Printable View (18 KB)	
TSB 04-15-6	<ul style="list-style-type: none"> • TR3650 MANUAL TRANSMISSION - JUMPS OUT OF GEAR 2ND AND/OR 3RD - CLASH NOISE AND/OR RASPY FEEL ON GEAR ENGAGEMENT
Publication Date: July 20, 2004

FORD: 2001-2003 Mustang

Figure 1 - Article 04-15-6

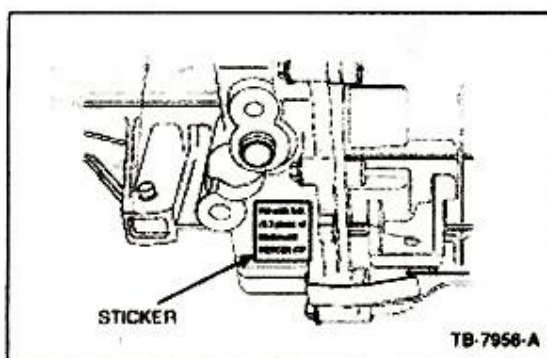
1. Remove the transmission from the vehicle.
2. Disassemble the transmission.
3. Install all of the revised components included in kit 3R3Z-7124-AC.
4. Clean oil from area 26 mm (1") below the transmission fill plug (Figure 1) and install the oil fill sticker included in the kit.

5. Reinstall the transmission.
6. Fill the transmission with 3.0 liters (6.3 pints) of Motorcraft Mercon ATF (XT-2-QDX). The full fill level is approximately 19 mm (0.75") below the fill hole.
